**Re: Hydro One Networks Inc. (Transmission)  
2017 and 2018 Transmission Revenue Requirement and Rates  
Application  
OEB Staff Interrogatories  
Board File No. EB-2016-0160**

**OEB Staff Interrogatories  
Hydro One Networks Inc. (Hydro One)  
2017 and 2018 Transmission Revenue Requirement  
and Rates Application  
EB-2016-0160  
August 9, 2016**

Figure 35: Projection of Steel Structures requiring Coating

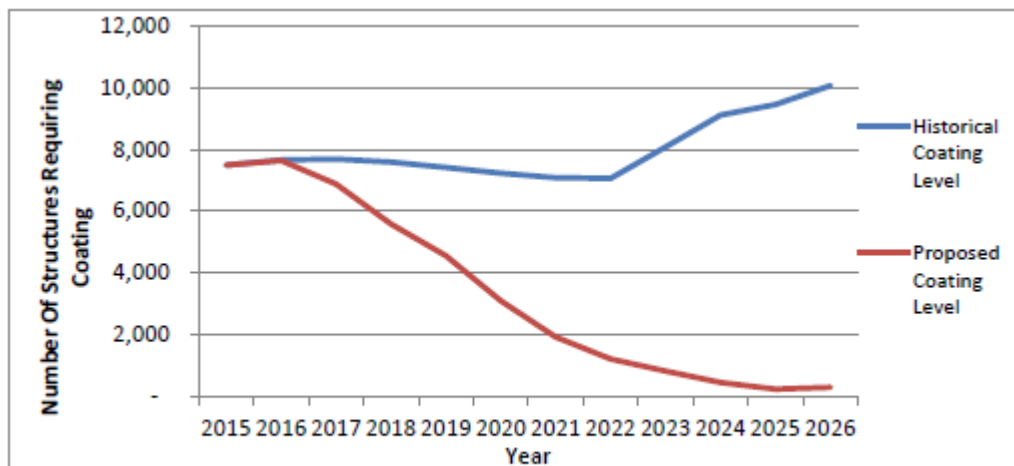
- a) Please show the expected rate of failure if the steel structure re-coating rate is maintained at the present rate rather than being increased by 34%.

- b) Please provide a quantified rationale for the increase in Steel Structure Coating program investments in 2017 and 2018 relative to historic years. What, if any, change does this increased level of investment indicate in Hydro One's Steel Structure Coating sustaining capital investment philosophy?

- c) Please provide a quantified rationale for doubling Steel Structure Foundation Refurbishment investments in 2017 and 2018 relative to historic years? What, if any, change does this increased level of investment indicate in Hydro One's Steel Structure Foundation sustaining capital investment philosophy?

- d) Please provide a quantified rationale for the increased Insulator Replacements in 2017 and 2018 relative to historic years. What, if any, change does this increased level of investment indicate in Hydro One's Insulator Replacement sustaining capital investment philosophy?

**Figure 13: Unavailability of Major Transmission Station Equipment**

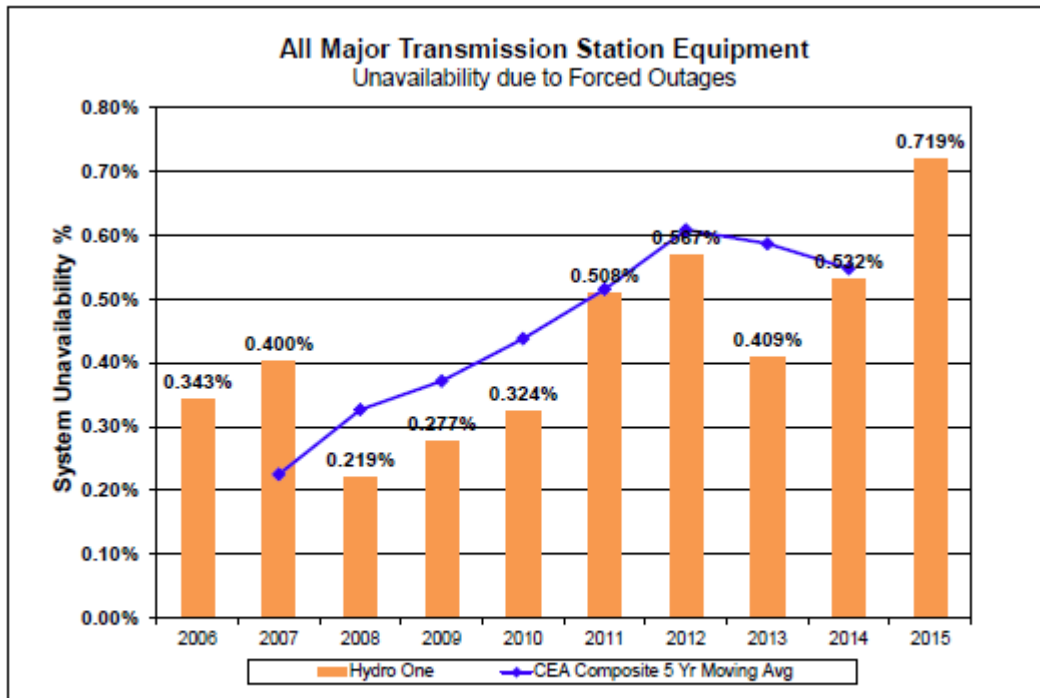
- a) Please comment on why RCE measures (Table 4, page 20 of B2-T1-S1) are declining (improving) from 2011-2015, while at the same time the ratio of unplanned station work to planned station work is increasing (worsening) (Table 6, page 23 of B2-T1-S1), and the Unavailability of Major Station Equipment due to forced outages (Figure 13, page 26 of B1-T1-S3) is increasing (worsening)?
- b) Are these metrics pointing to different conclusions? Please explain in detail.
